LONG TERM ICE CONDENSER CONTAINMENT CODE-LOTIC CODE

WCAP-8355-A
Revision 1

SUBJECT: RESULTS OF THE U.S. NUCLEAR REGULATORY COMMISSION
REVIEW OF WESTINGHOUSE ELECTRIC COMPANY (WESTINGHOUSE)
CHANGES IN WESTINGHOUSE WCAP-8354-P-A (PROPRIETARY) AND
WCAP-8355-A (NON-PROPRIETARY), "LONG TERM ICE CONDENSER
CONTAINMENT CODE - LOTIC CODE" (CAC NO. MF9354)

RAI Response Regarding WCAP-8354-P-A & WCAP-8355-A,
“Long Term Ice Condenser Containment Code - Lotic Code”

Figure 1 Containment Pressure Comparison

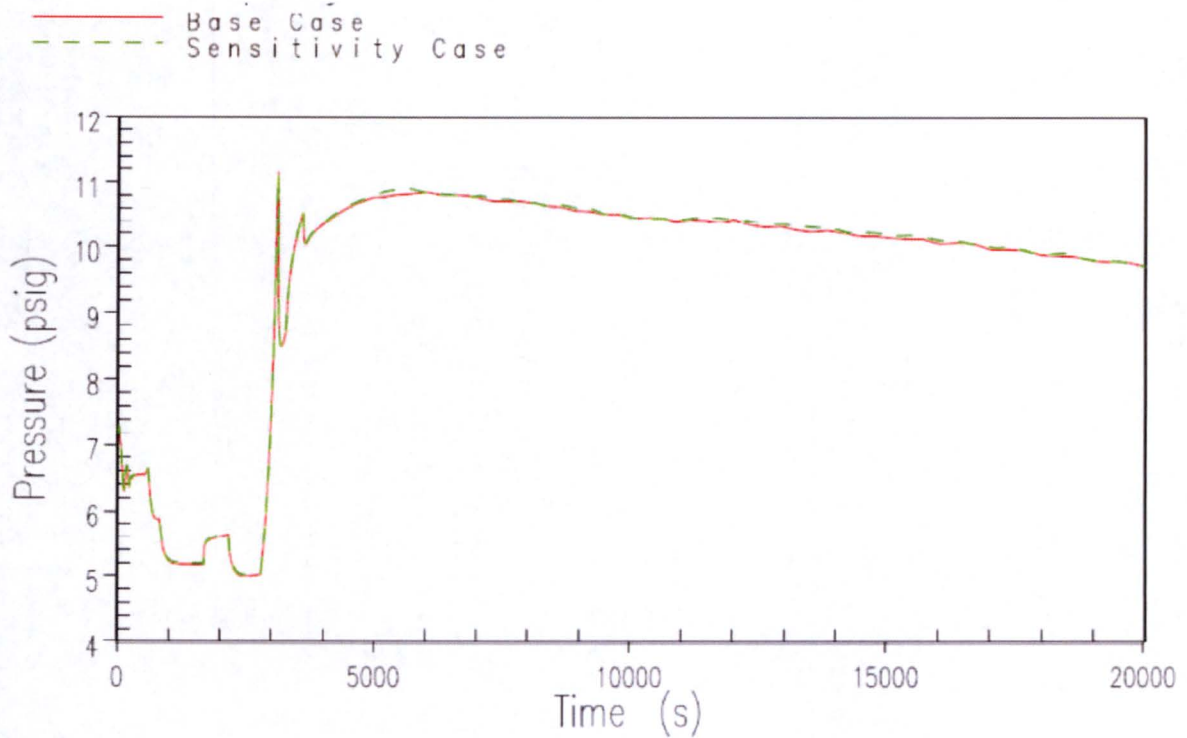
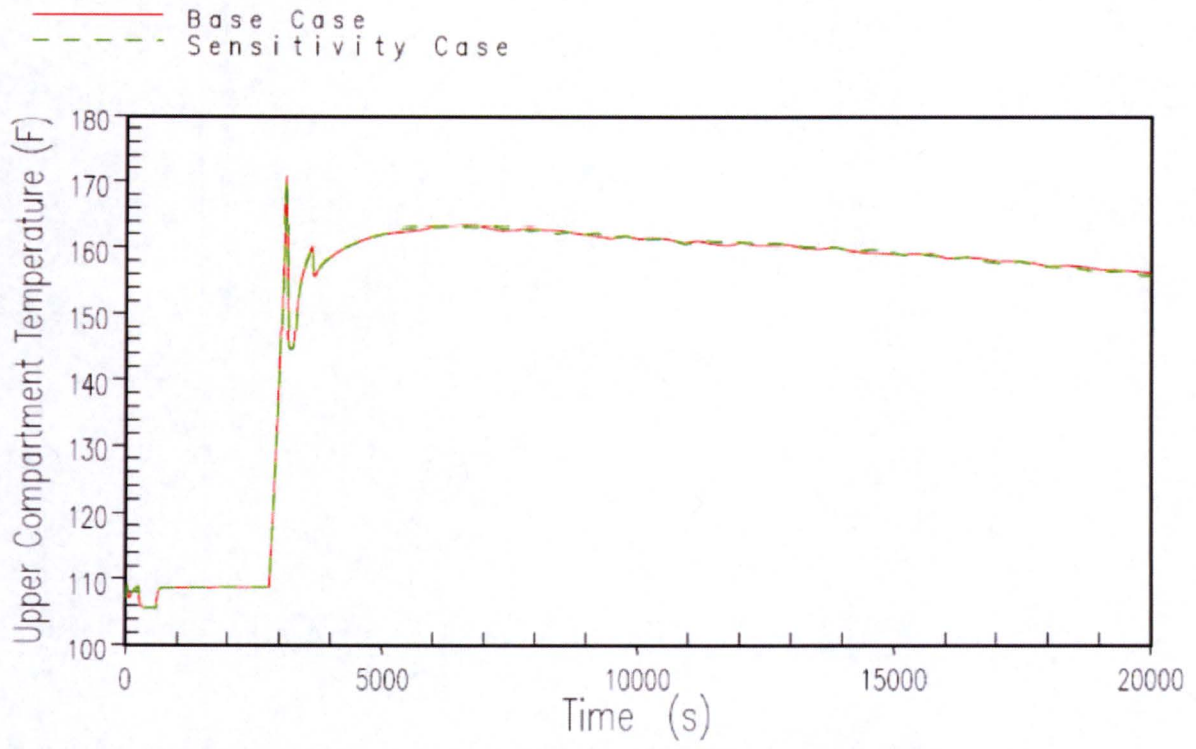
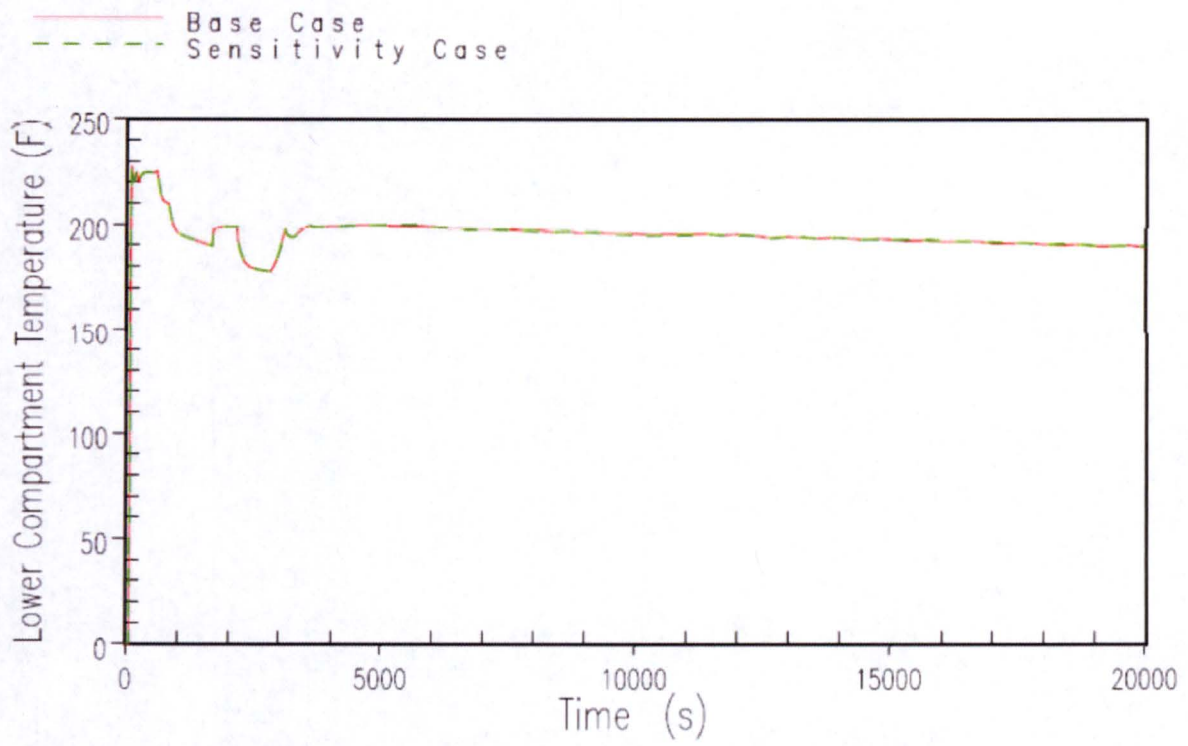
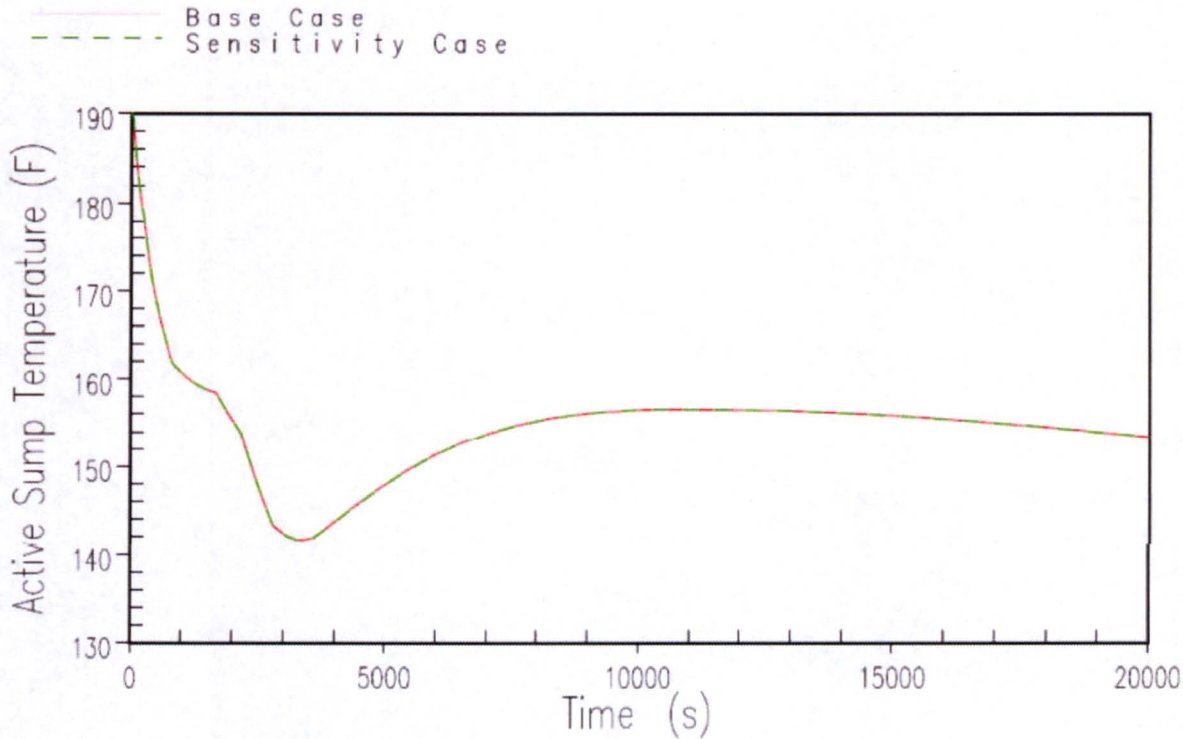
SRXB-RAI 1 – The addition of “ice-empty part of the ice compartment” in [1] appears to be a significant change in the total volume (lower compartment volume + ice-empty volume) which is compared with the expanding volume, because the ice-empty volume varies from zero (or a small volume) to the full volume of the ice-compartment during the depressurization phase. Provide a quantitative impact of this change on the entire pressure response, including the peak pressure, by performing a sensitivity analysis for the most bounding ice-condenser plant in the United States.

Please state by what method it was determined that the affected portion of the transients (containment pressure, containment temperature, and sump temperature) would have a negligible impact. Provide quantitative results by performing sensitivity study showing negligible effect on the above transients and their peak values for the most bounding ice-condenser plant in the United States.

Westinghouse Response: A temporary version of the LOTIC1 code was created to model the treatment of the lower compartment volume as it is currently described in WCAP-8354-P-A. The lower compartment conditions were considered in the system pressure calculation of this temporary LOTIC1 code version after the air bubble had expanded to fill the lower compartment.

The currently most limiting containment model input deck for the peak pressure case was used with this temporary LOTIC1 code version to generate a transient pressure response for a sensitivity comparison with the base case analysis results.

Westinghouse Response: Engineering judgment was originally used to determine that making this change would have a negligible impact on the analysis response. See the response to SRXB-RAI-1 for the requested quantitative results comparison.
